NOTICE OF REVIEW OF DETERMINATION

Development Application No: DA/331/2019

Property Address: 23 Belmore Road, RANDWICK NSW 2031

DA REPORT – Division 8.2 Review

Figure 6. DA proposal (Belmore Road to the left)

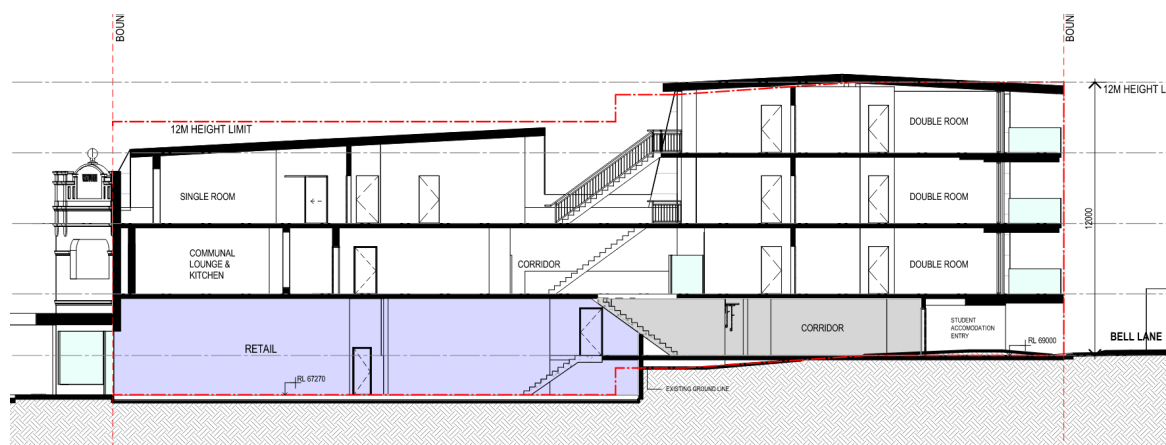
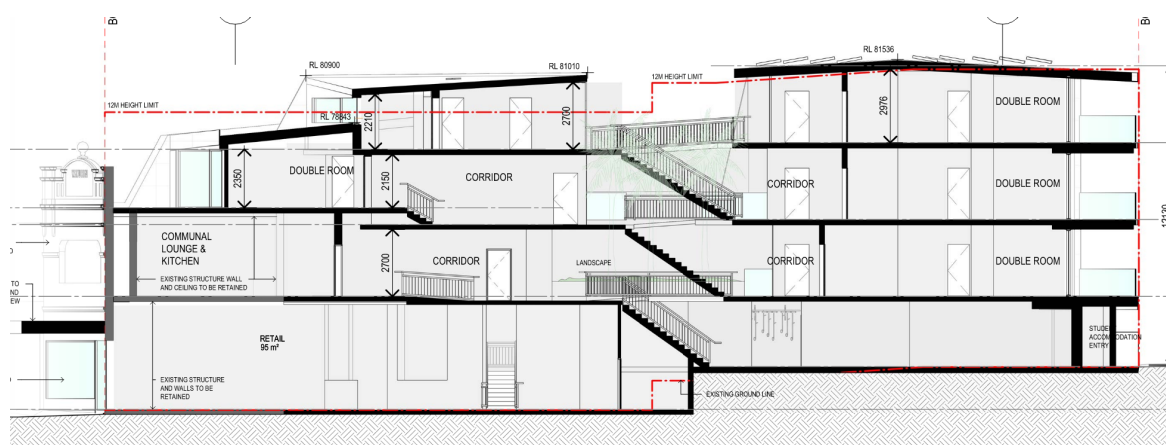
- Design Excellence Panel concerns with regards to setback of level 2 to Belmore Road and inadequate size of the boarding rooms.

The submitted DA includes increased density and scale compared to the drawings submitted as part of the pre-lodgement, with the concerns raised at the pre-lodgement stage still relevant.
